**HISTORIC PRESERVATION BOARD
REVISED APPLICATION**

05/14/2024

PREPARED BY:
**JAMES
CORNER
FIELD
OPERATIONS**

LINCOLN ROAD DISTRICT IMPROVEMENTS PHASE 3

EUCLID OVAL PAVING
PRECAST CONCRETE HEX PAVER ALTERNATIVE (05/14/2024)

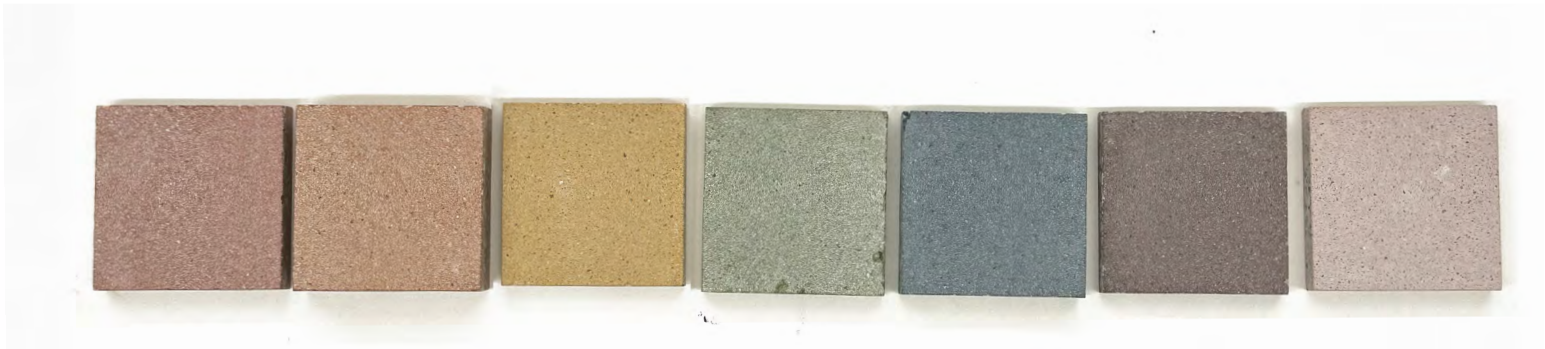
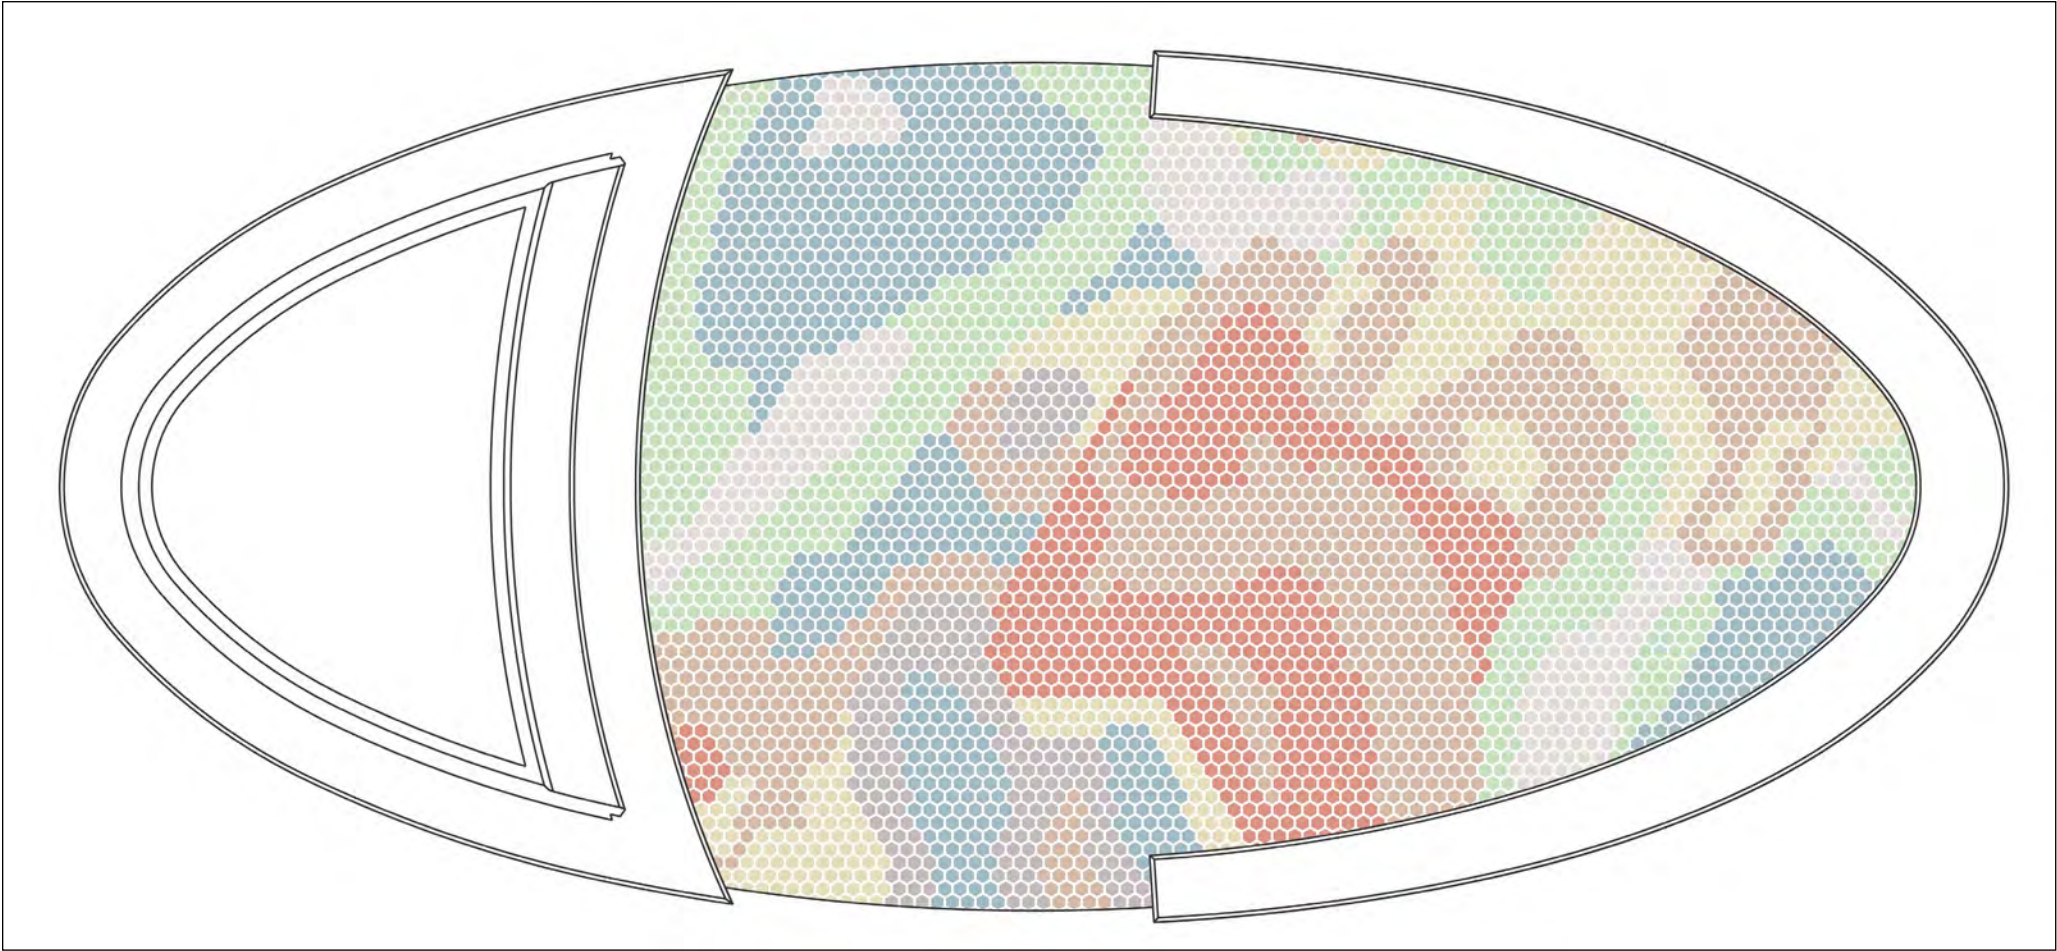
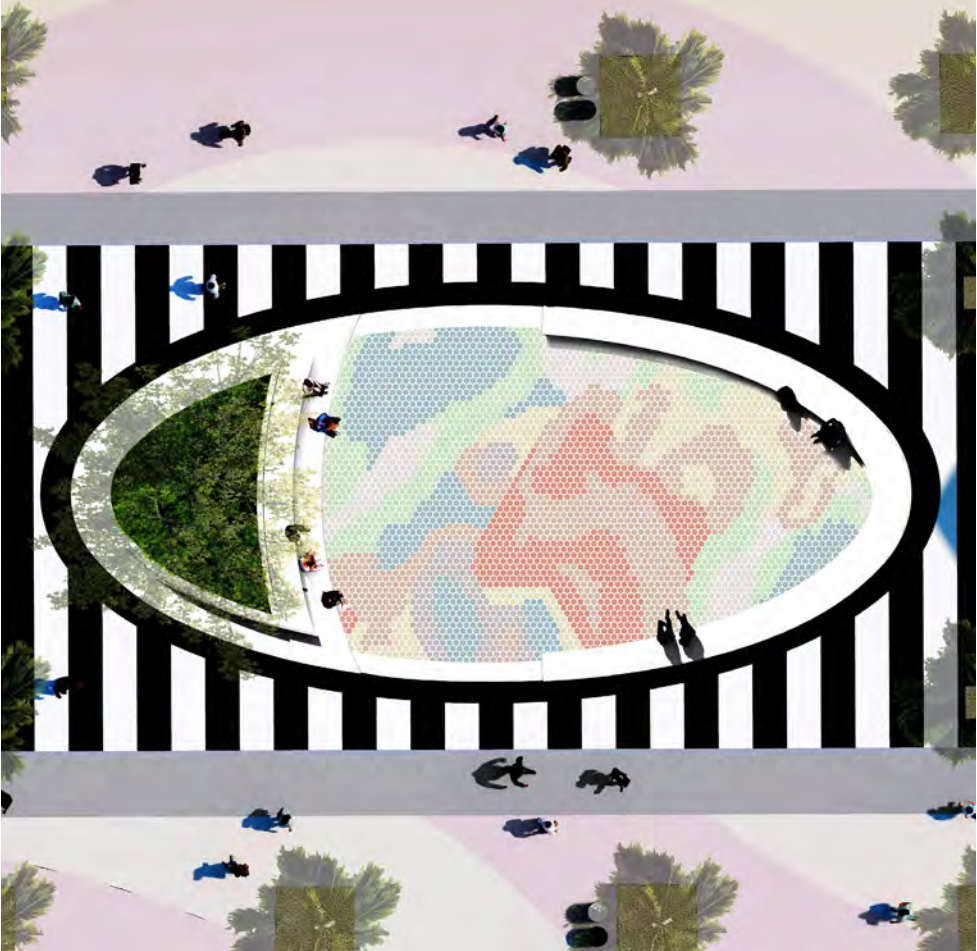
PAVING- CONSIDER OTHER MATERIAL ALTERNATIVES TO PROPOSED CERAMIC TILE

EUCLID OVAL PAVING
OPTION 2- 8" HEXAGONAL PRECAST CONCRETE PAVERS (05/14/2024)

LINCOLN ROAD WAYFINDING SIGNAGE
REVISED DESIGNS 05/14/2024

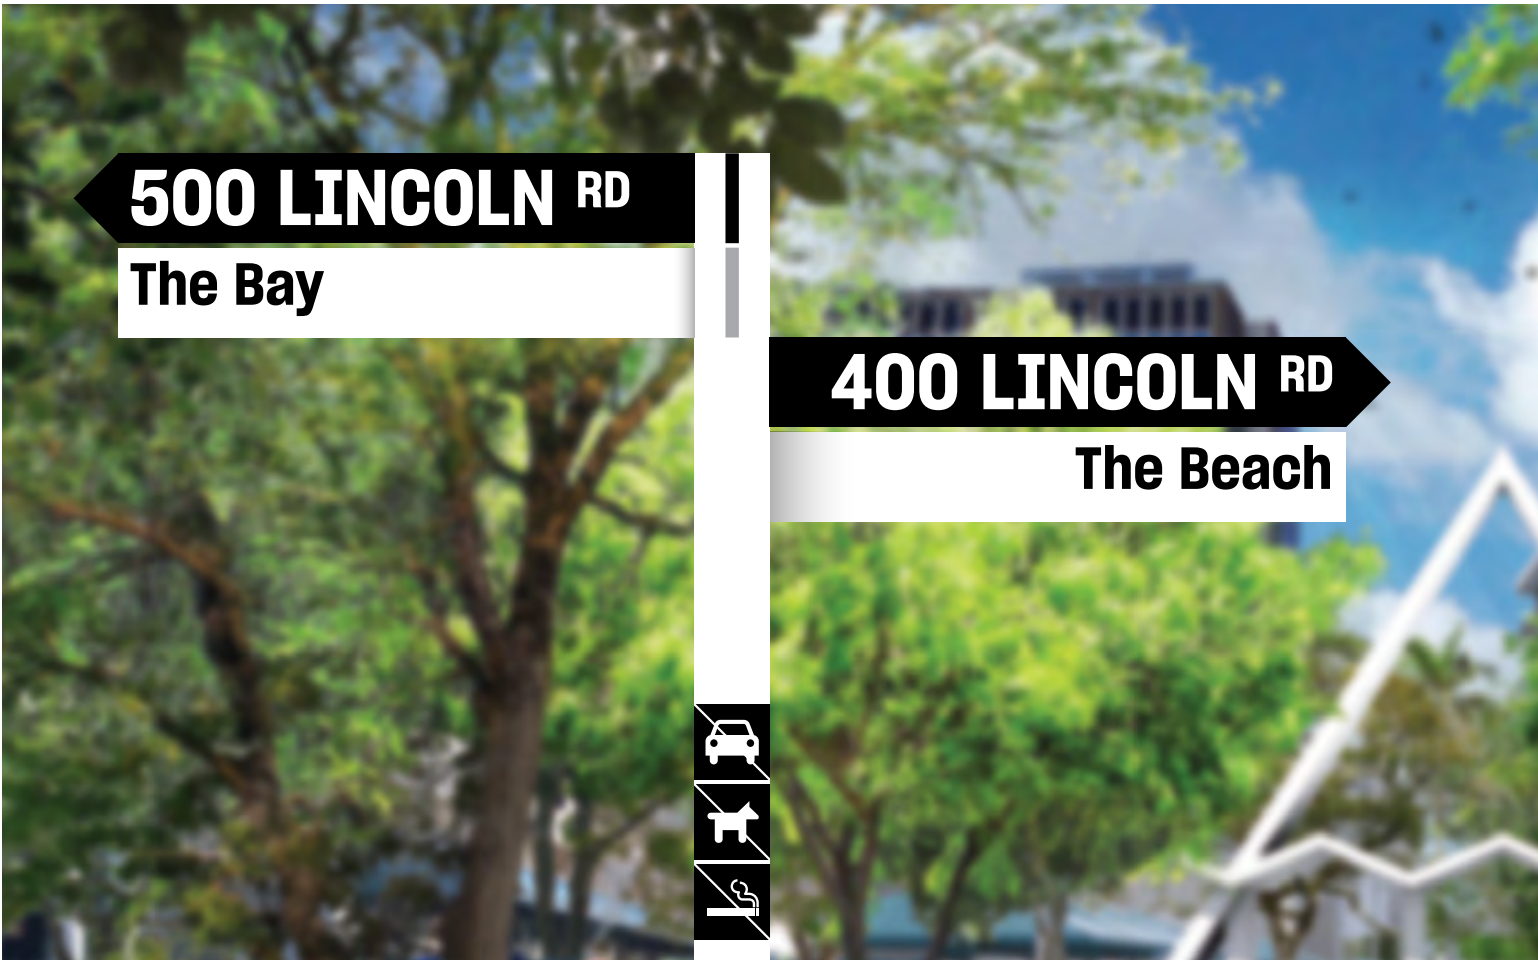
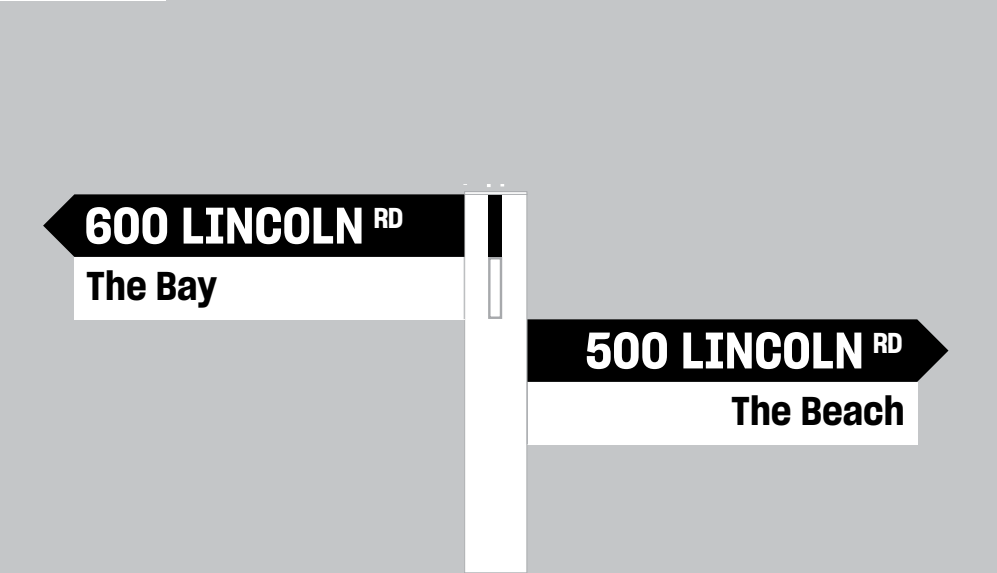
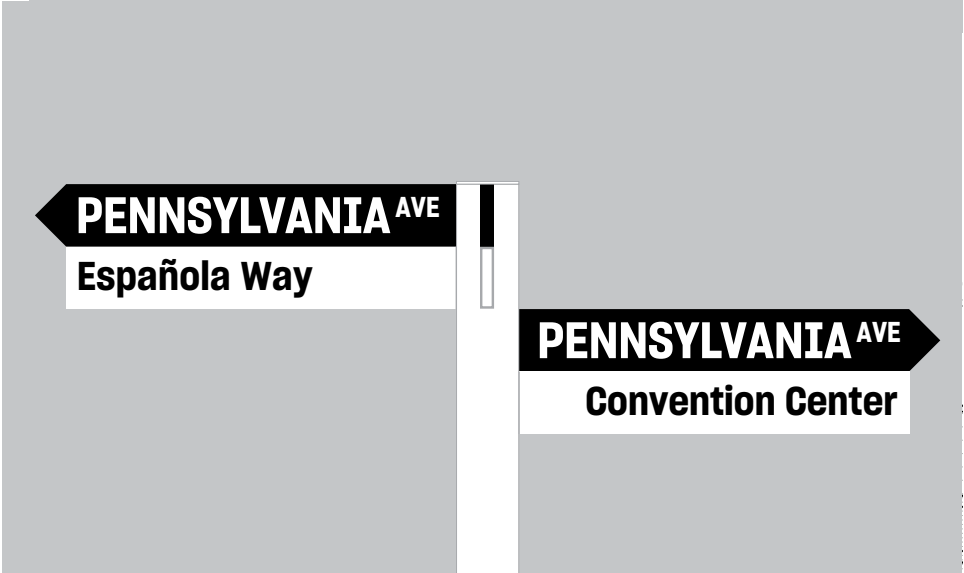
CLARIFY DESTINATION SIGNAGE INTENT

SIMPLIFY SIGNAGE
